DEVELOPMENT REVIEW BOARD REPORT

SUBJECT	Preliminary Plat
REQUEST	<p>Request to approve a Preliminary Plat for 20 single family residential lots with amended development standards on a 10+/- acre parcel.</p> <p>1-PP-2004</p> <p>Key Items for Consideration:</p> <ul style="list-style-type: none">• The R1-10ESL site zoning conforms with the properties to the east, west and north sides• Applicants have agreed to conform to ESLO-2 standards including 24 ft. building heights• No objections have been received from neighbors
OWNER	<p>Burns Brothers Holdings 480-429-2354</p>
APPLICANT CONTACT	<p>Paul Thorp H T P O, Inc 480-836-0535</p>
LOCATION	<p>11421 N 124th St, Northeast corner of 124th St. and Via Linda</p>
BACKGROUND	<p>Zoning.</p> <p>The site is zoned R1-10 ESL. This zoning district(s) allow for single-family residential lots with minimum sizes of 10,000 sq. ft. This area was annexed as R1-43 in 1975. Case 64-ZN-89 rezoned the area to R1-10 in 1989. Case 17-ZN-91 amended right of way stipulations for the 56-acre R1-10 property including Desert Orchid to the west, Parker Place I to the north and the site.</p> <p>Context.</p> <p>This subdivision is located in the East Shea area of the

BIKEWAYS AND TRAIL EXHIBIT

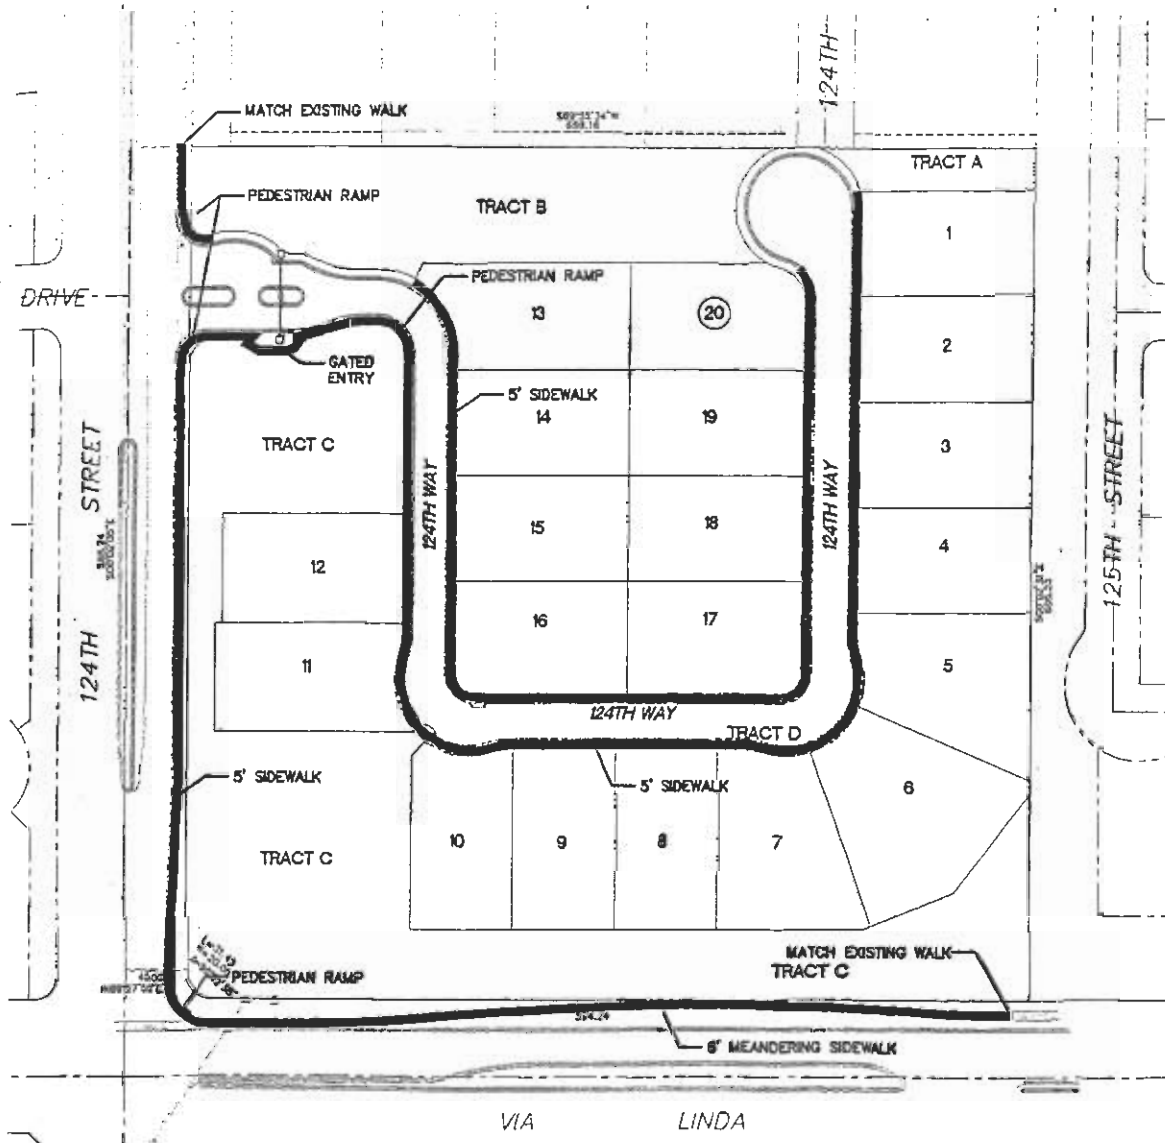
- 1. The multi-use public trail on the east side of 124th Street shall be shown on the final plat.*
- 2. All trail alignments shall be subject to the review and approval of the Parks and Trails Coordinator and Plan Review staff. These public trails shall be dedicated in the form of easements, to the satisfaction of City staff.*

3. *The City's Trail Planner and the Plan Review staff shall approve the location, details, and construction materials of the trail crossing of the plat access road.*
4. Paths and public use trails shall be consistent with the Design Standards and Policies Manual for the City of Scottsdale.
